Office Action Summary

10/675,088

PARK ET AL.

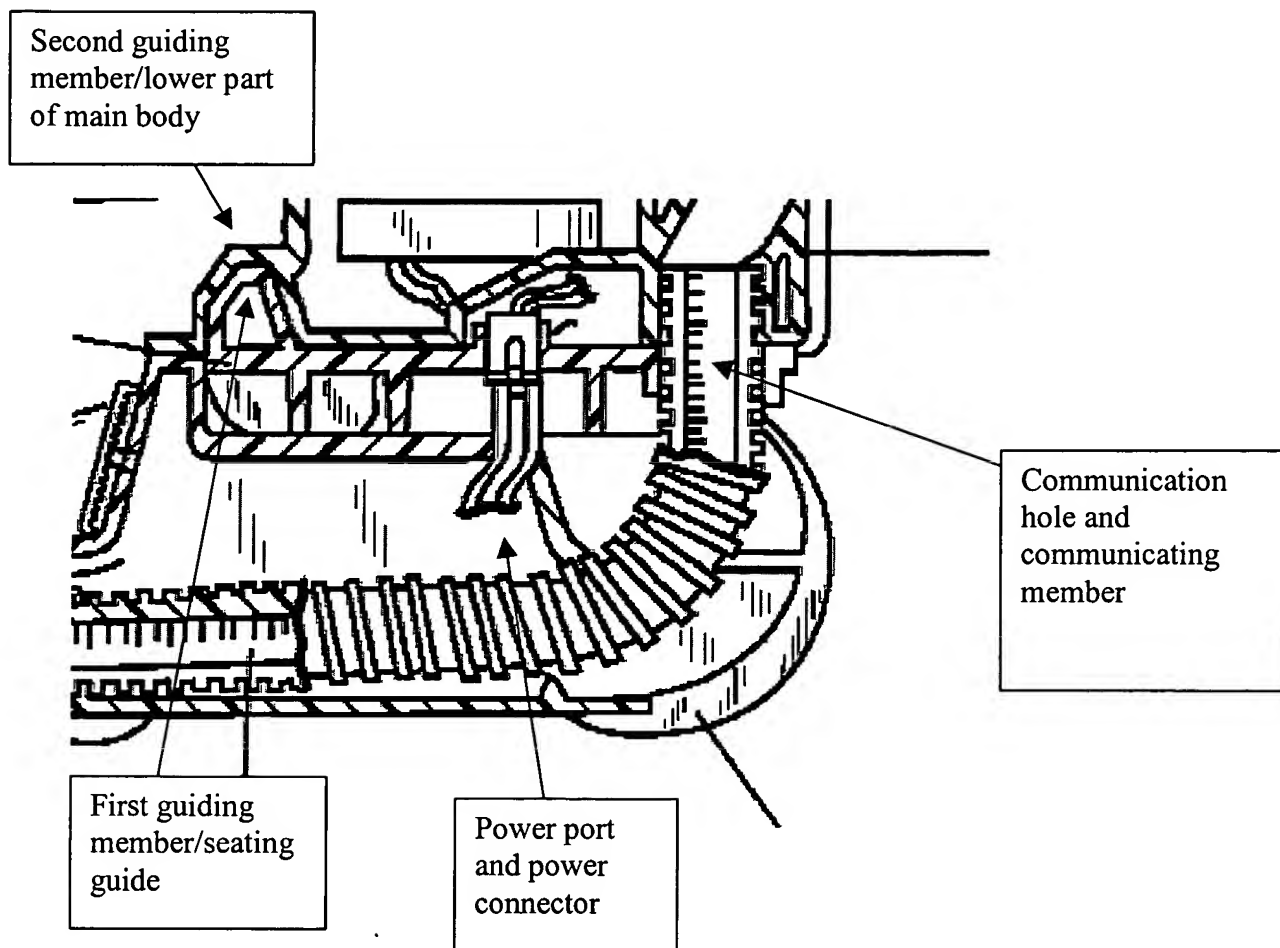
assembly is directed to the main body of the vacuum and a communicating member (94) connected to the communicating hole is formed at the main body of the vacuum (see figure below)

With regards to claim 11, there is a power port on one side of the connecting portion for providing power from the main body and a power connector disposed on the lower part of the main body to be connected to the power port (not labeled but shown on figure 6 to the left of the communication hole) (see figure below).

With regards to claim 12, there is a first guiding member on the connecting portion and a second guiding member corresponding to the first guiding member on the lower part of the main body (see figure below).

With regards to claim 13, the first guiding member is shaped in to a convex protrusion (cross section shows a convex shape in figure below) and the second guiding member is shaped in to a concave groove (cross section shows a concave groove in figure below).

With regards to claim 15, there is a seating guide on the connecting portion corresponding to the lower part of the main body of the vacuum cleaner (see figure below).

With regards to claim 16, the seating guide is shaped as a convex protrusion (cross section shows a convex shape in figure below) and the lower part of the main body is shaped as a concave groove (cross section shows a concave groove in figure below).
